ADDENDUM NO. 1

PROJECT NAME: Nebraska Union First Floor Selective Refurbishment
UNL PROJECT NUMBER: C026P336
BID INVITATION NUMBER: 2209-13-7200

CONSULTANT: Holland Basham Architects
ADDRESS: 119 S. 49th Ave, Omaha, NE

DATE OF ISSUANCE: 20 August 2013
DATE OF BID OPENING: 27 August 2013

1
D1.1

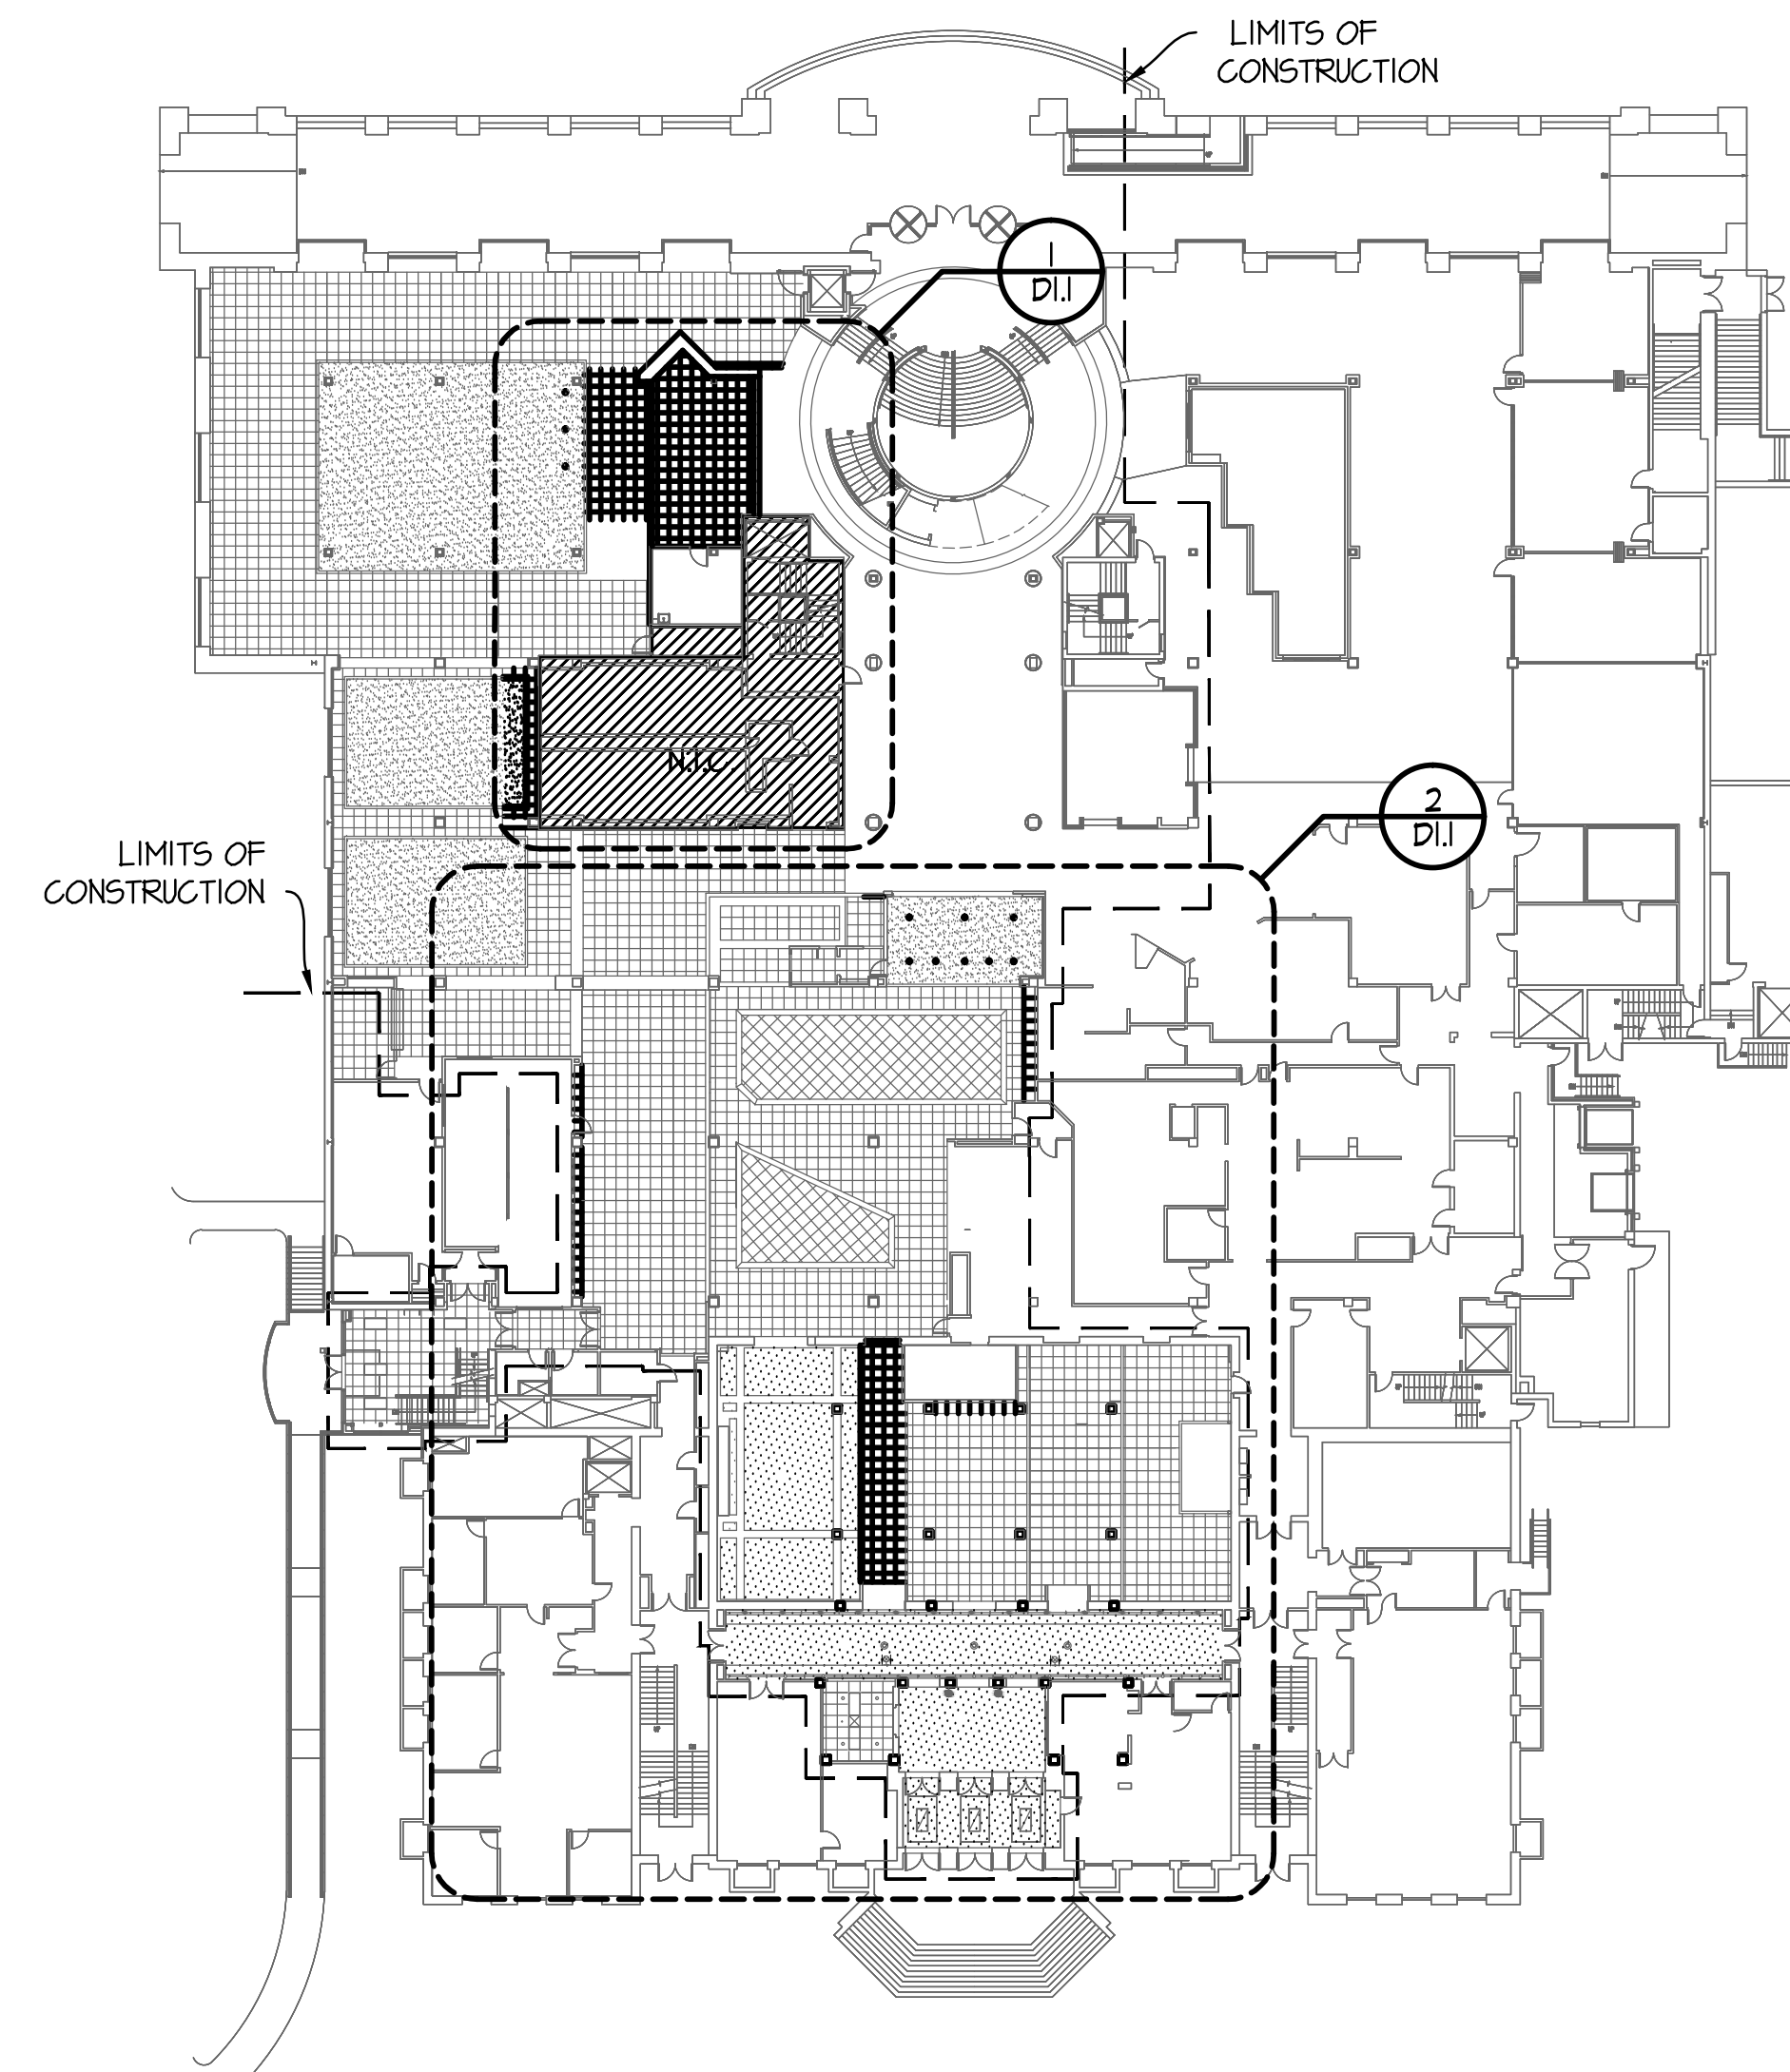
1. Delete the following keyed notes:
 - a. Corridor 126: number 14
 - b. Lobby 128: numbers 1 & 14
 - c. Vestibule 129: number 14
2. Modify lights in Vending area 128A to be shown as existing.

**OVERALL
FLOOR PLAN**

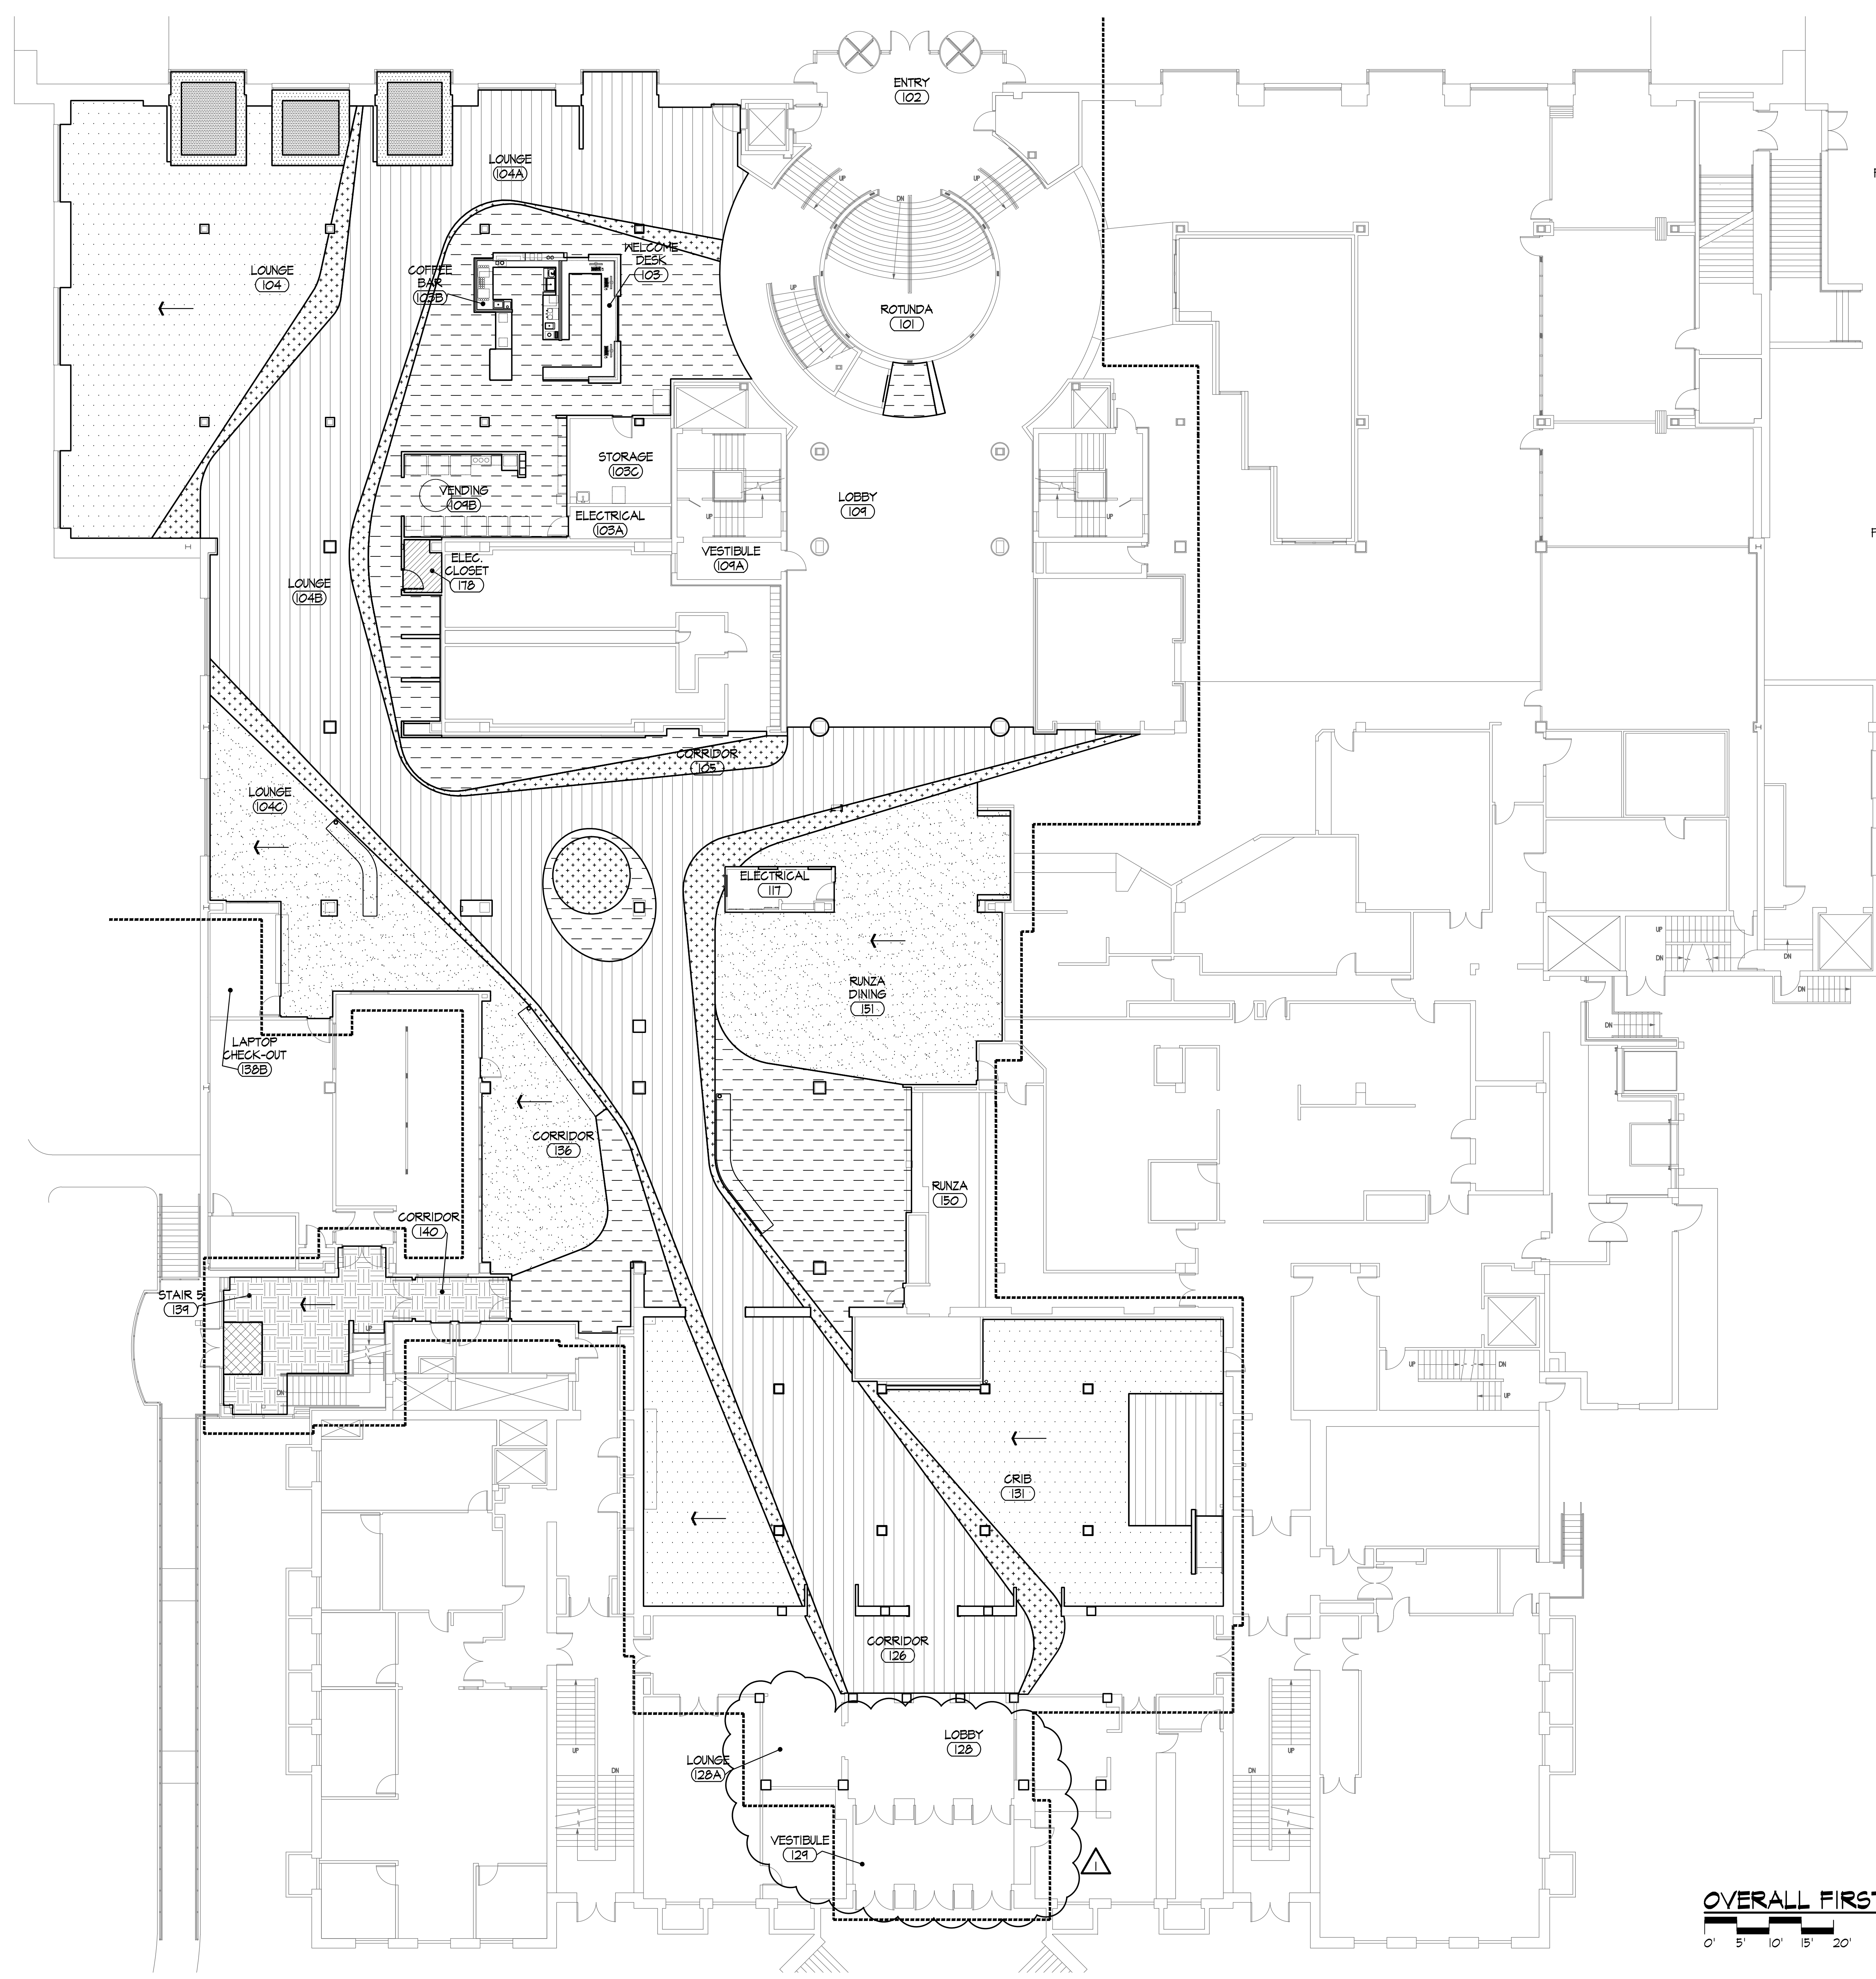
1. Delete the following keyed notes:
 - a. Keyed Demolition Notes: numbers 6, 9, 12, 15 & 39
 - b. Corridor 126: numbers 4, 17 & 39
 - c. Lobby 128: numbers 4, 9, 15 & 17
 - d. Lounge 128A: number 20
 - e. Vestibule 129: numbers 9, 12, 17, 18 & 20

**ENLARGED
FLOOR FINISH PLAN**

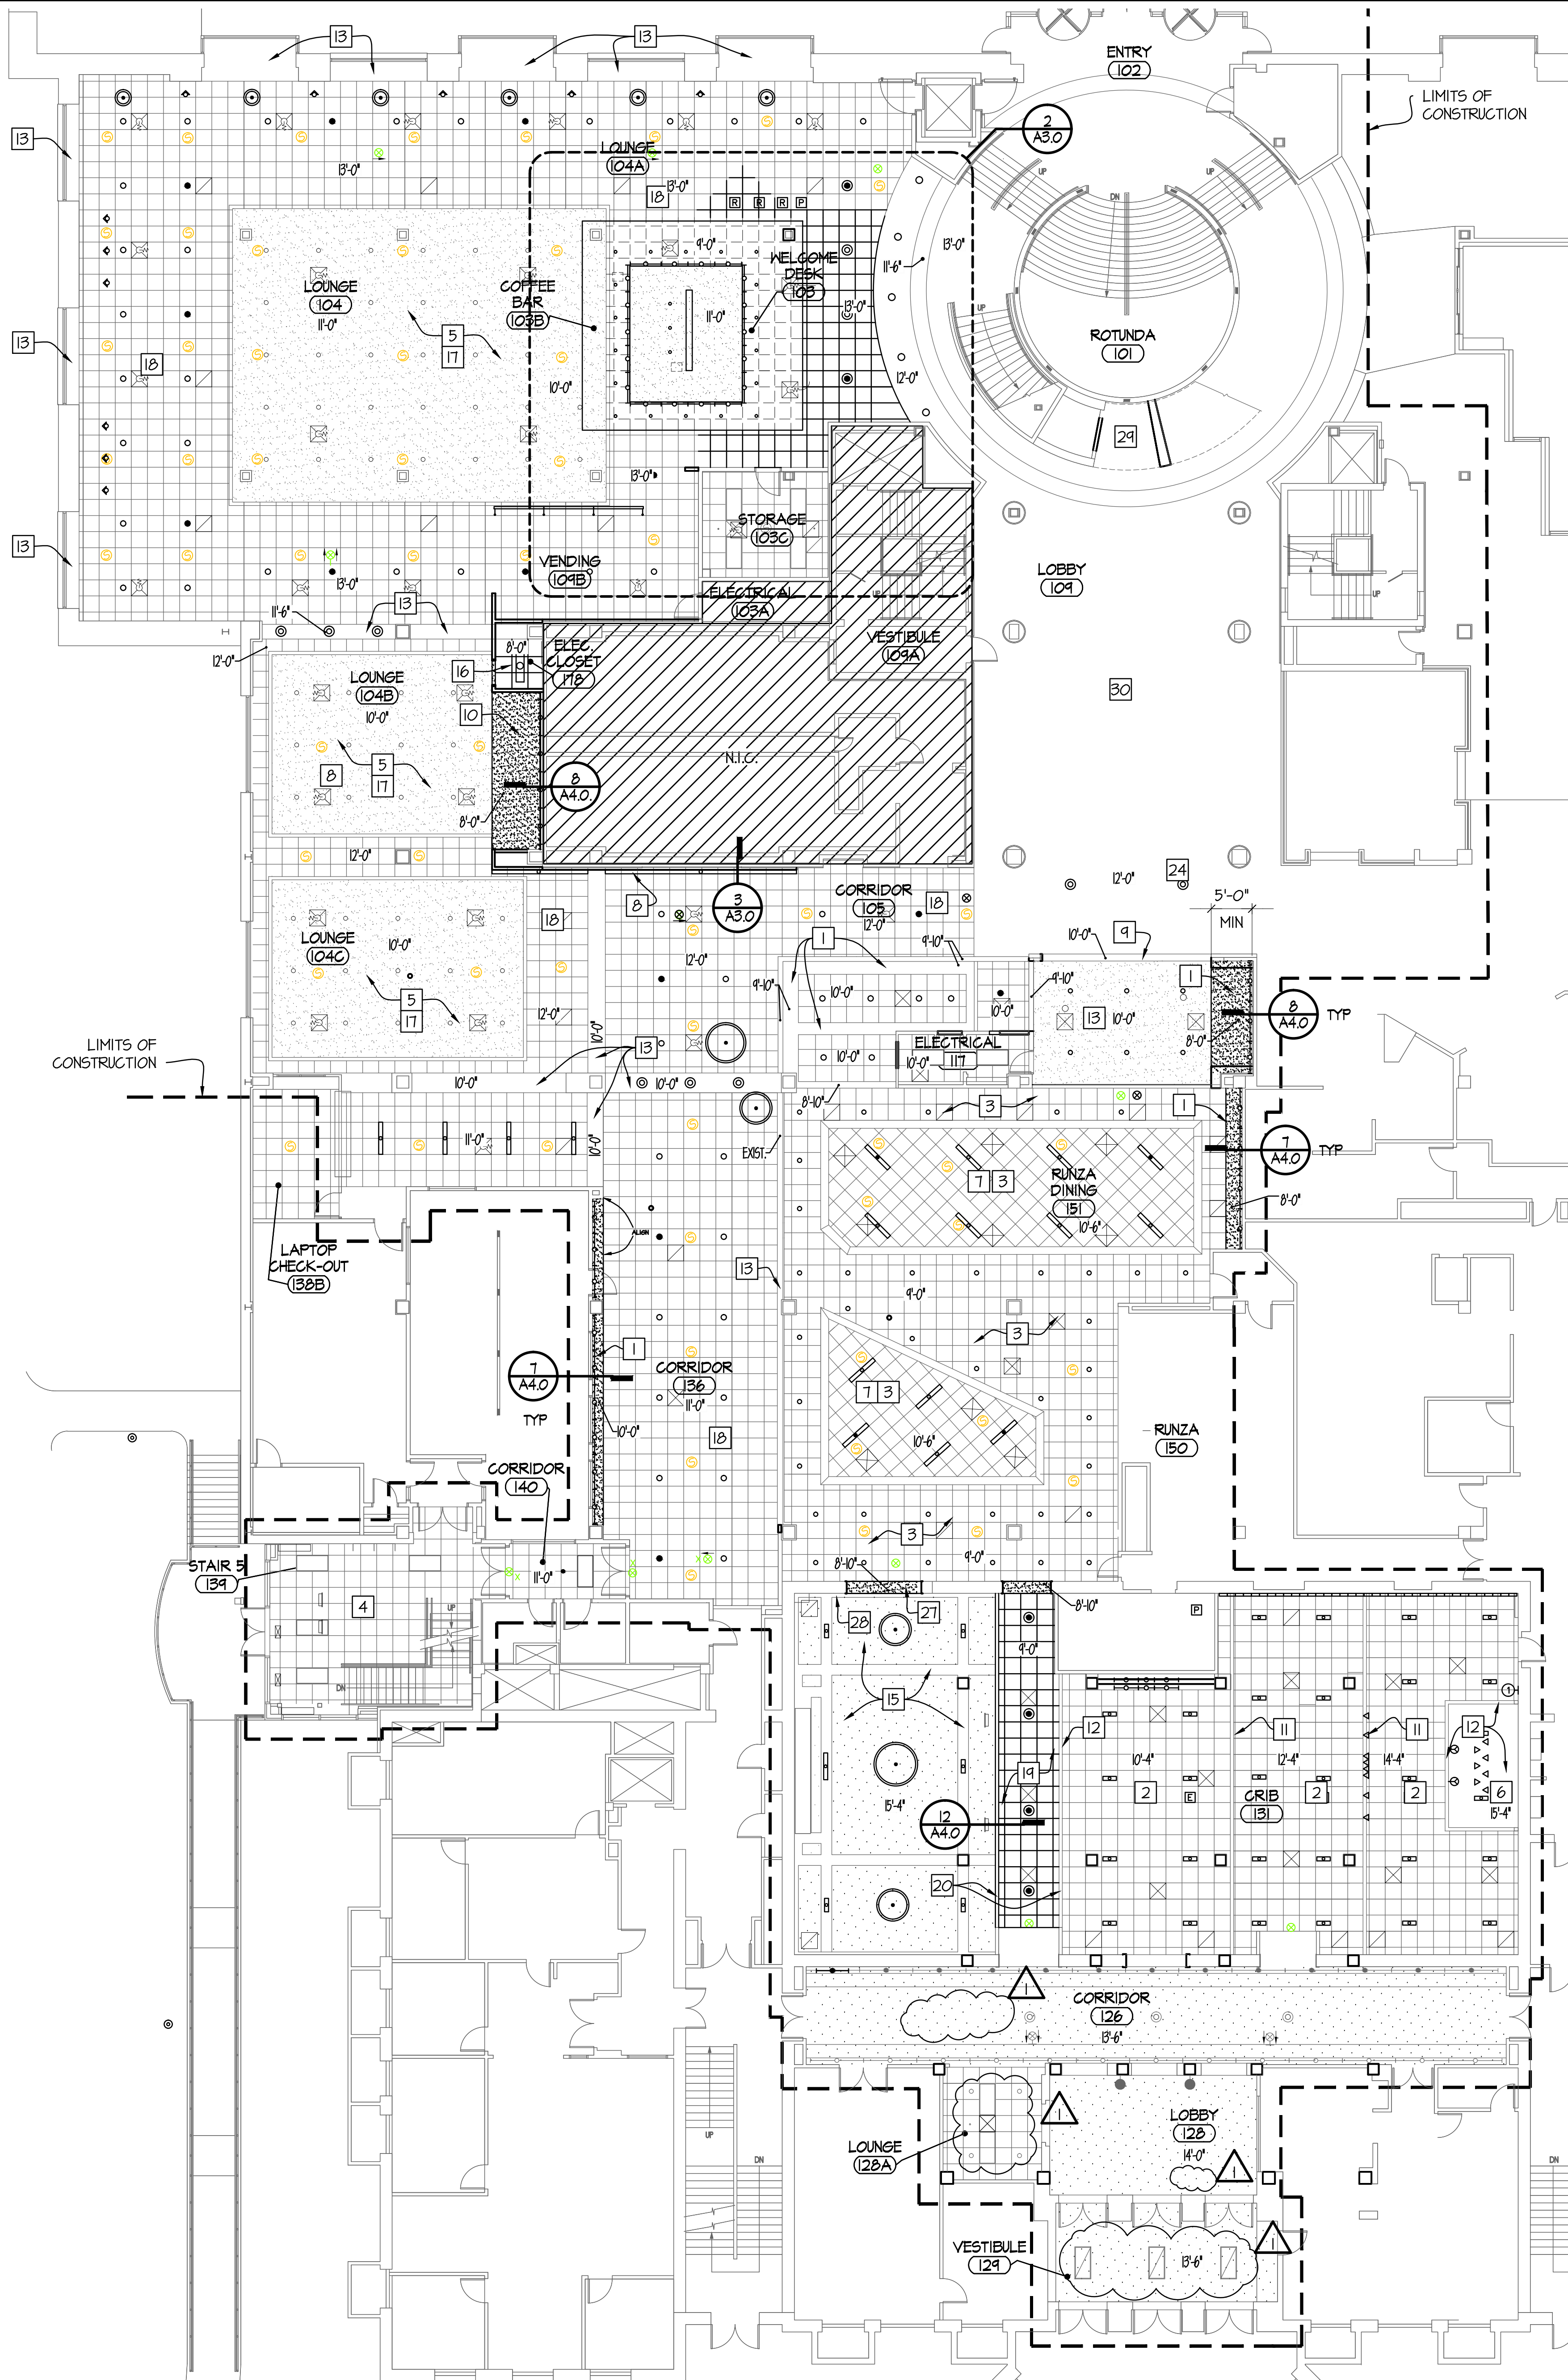
1. Delete the following:
 - a. Lounge 128A: Keyed note 5 & dashed line indicating paint extents.
